## Product Change Notice (PCN)

PCN Number: PCN-0450983R-01

Product(s) Affected: *SJ1-353XNS Series (SJ1-3533NS, SJ1-3534NS & SJ1-3535NS)*

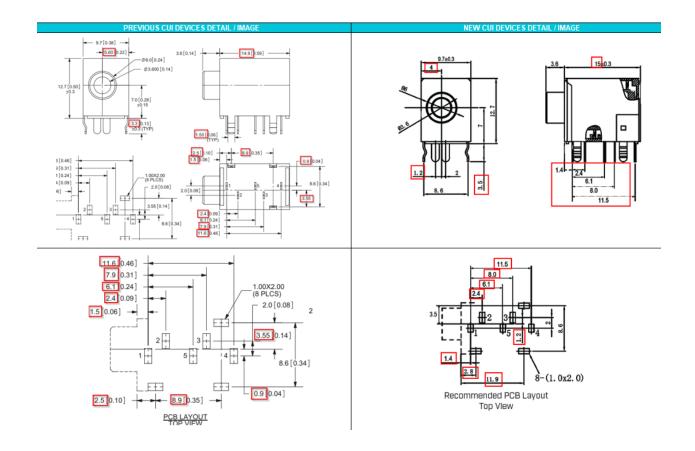
Description of Change: Minor Housing and footprint differences. Material Change on the housing and terminals. See image Below

PREVIOUS CUI DEVICES DETAIL / IMAGE				NEW CUI DEVICES DETAIL / IMAGE				
	MATERIAL	PLATING	-	DESCI	RIPTION	MATERIAL	PLATING/COLOR	
terminal 1	brass	tin	-	termir		brass	silver	
terminal 2	brass	tin		termir	al 2	phosphor bronze	silver	
terminal 3	brass	tin		termir	al 3	phosphor bronze	silver	
terminal 4	brass	tin		termir	al 4	brass	silver	
terminal 5	brass	tin		termir	al 5	brass	silver	
spring	stainless steel		_	spring		stainless steel	nickel	
bushing	brass	nickel		bushir	ng .	brass H59	nickel	
				shield		SPCC t=0.30	nickel	
shield	cold rolled steel	nickel	-	housir	ng	PBT (UL94V-0)	black	
plastic	PBT		-		_
